PLANNING, ZONING, & BUILDING DEPARTMENT
PZ&B Staff Memorandum: Architectural Commission

SUBJECT: ARC-24-0096 150 WORTH AVE

MEETING: NOVEMBER 22, 2024, ARCOM

ARC-24-0096 150 WORTH AVE—THE ESPLANADE. The applicant, Wilson 150 Worth LLC, has filed an application requesting Architectural Commission review and approval for updated paving, updated railings, removal of the main central staircase, and the addition of a water feature for the Esplanade.

EXISTING CONDITION

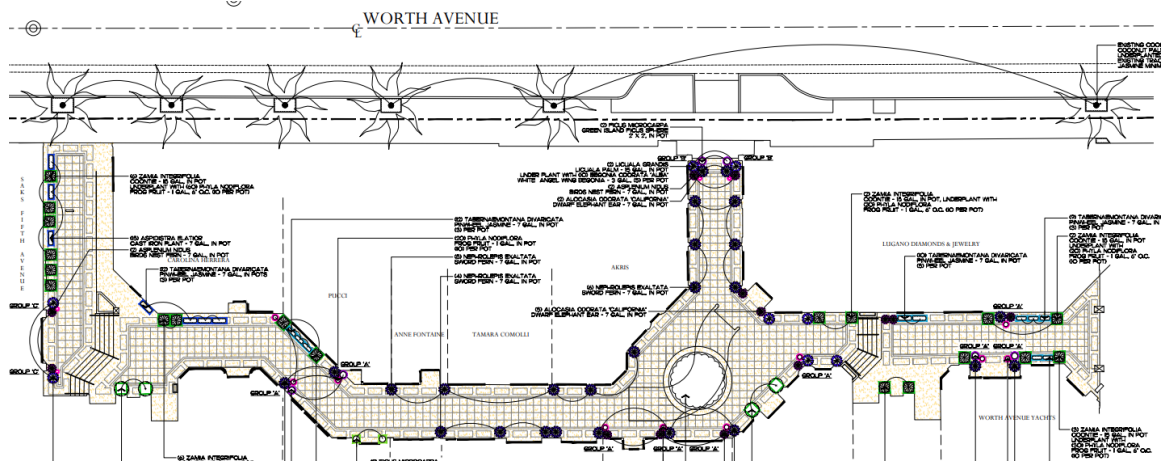
The applicant is proposing to refresh the interior courtyard of the Esplanade shopping area. This includes a change in paver material. The proposed materials are limestone in agrande burn, cast stone and travertine in ivory creme. This would include installation of additional drainage areas concealed with drain covers.

The second most visible change will be a new railing pattern that is visually lighter and vertically straight instead of bowed.
